Upper Occoquan Service Authority

For UOSA IFB 19-09, Phase II Nutrient Compliance Settleability Pilot Plant

SUBJECT: Addendum #2

DATE	DECEMBER 2018
PROJ	699347
DWG	G-12
SHEET	12

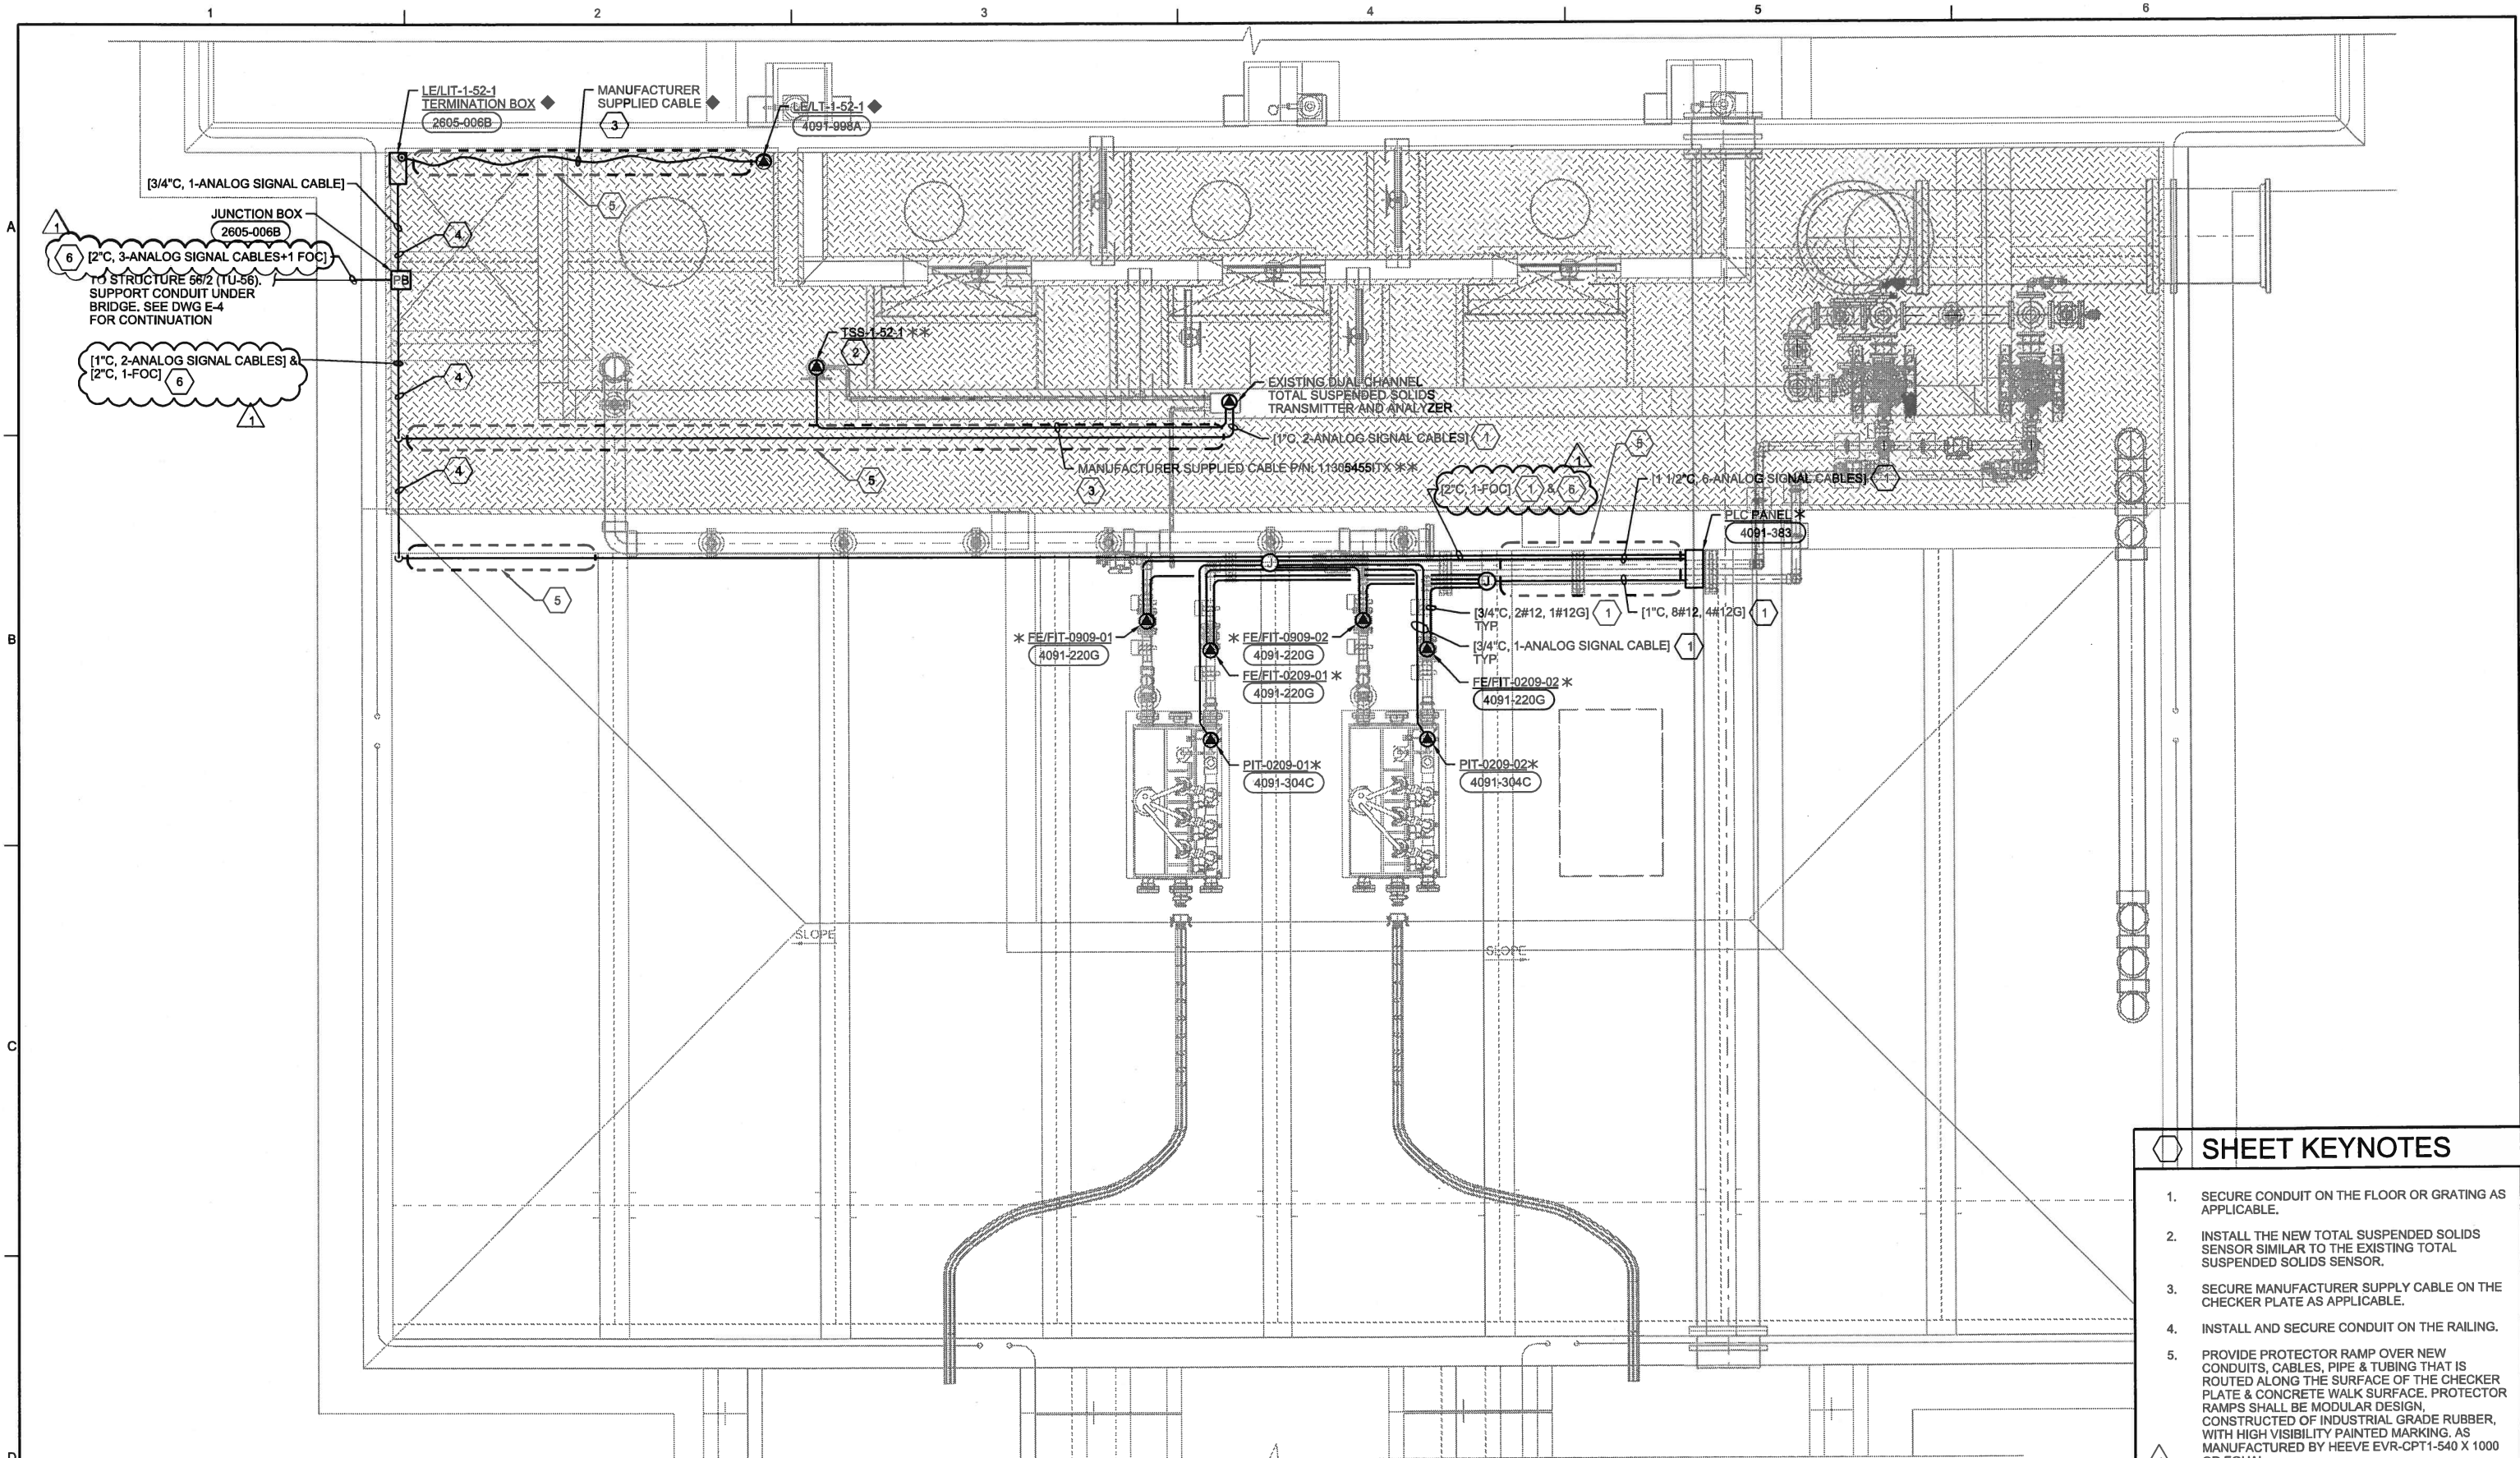
2. This addendum also provides the pre-bid minutes as Attachment A to this addendum.
3. This addendum provides updated drawings as a result of corrections, changes or clarifications. Attachment B to this addendum provides the following updated drawings. Previous versions of these pages should be removed from the original package and replaced with the drawings provided as part of this addendum:
 - a. Electrical and Instrumentation and Control Notes and Specification, Drawing G-12, Sheet 12
 - b. Selector Basin 56/1 Pipe Gallery Electrical Top Plan, Drawing E-2, Sheet 29
 - c. Selector Basin 56/2 Pipe Gallery Electrical Lower Plan, Drawing E-4, Sheet 31
